STATE OF NEW YORK
DEPARTMENT OF TRANSPORTATION

SHOULDER PERFORMANCE
EVALUATION REPORT

SOIL MECHANICS BUREAU

Subject: Roadway Shoulder Performance

Photo 1

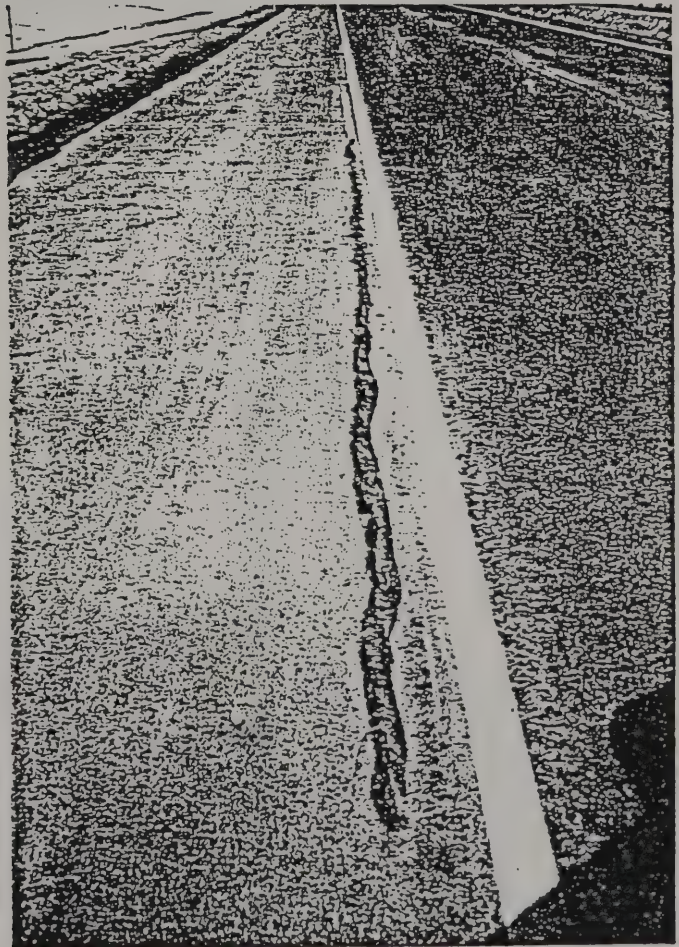
Attached are several photographs taken of shoulders throughout the state which show various distress conditions. Older shoulders show the alligator cracking next to the mainline pavement and a loss of surface material. It is noteworthy that recent construction also showed problems which are likely to lead to early distress of the shoulders. On the Alternate Route 7 construction, the ACC shoulders were separated from the PCC pavement. The Cohoes Arterial showed signs of early cracking next to the mainline which have been sealed. The Route 9W project near the Coeyman's Kill Bridge also showed early cracking. Other photos are provided as examples of shoulder distress.

There is concern by the FHWA that roadway shoulders designed and constructed in New York generally are not performing adequately. Corrective action by maintenance is needed (but often deferred) on many shoulders too soon after their initial construction. There are numerous examples around the state of faulted longitudinal joints between the mainline pavement and the shoulder as well as alligator cracking with resulting loss of surface material.

Photo 10

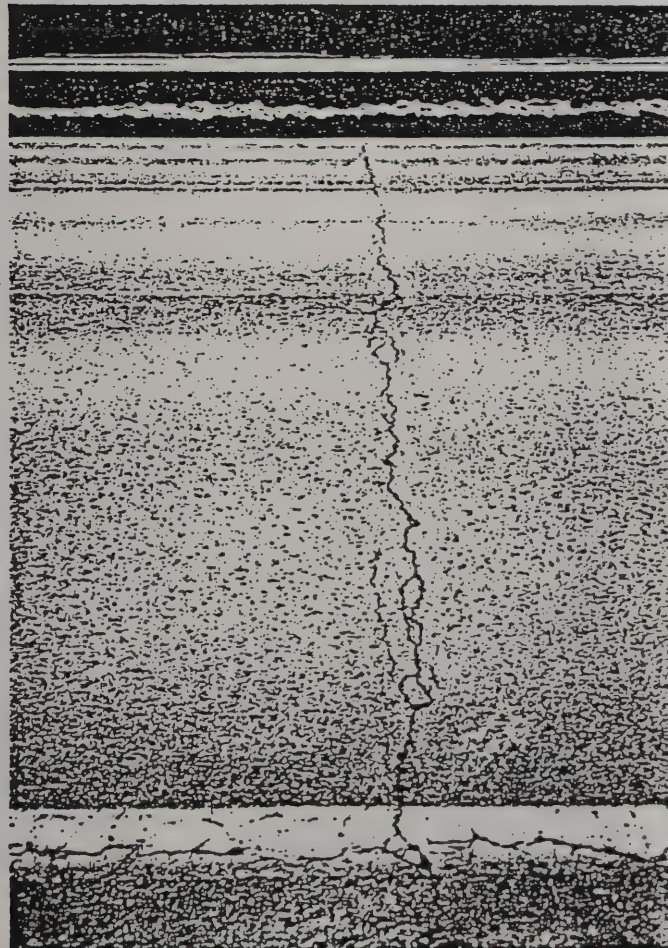
Example Of Transverse Cracking Of
Resurfacing Over P.C.C.
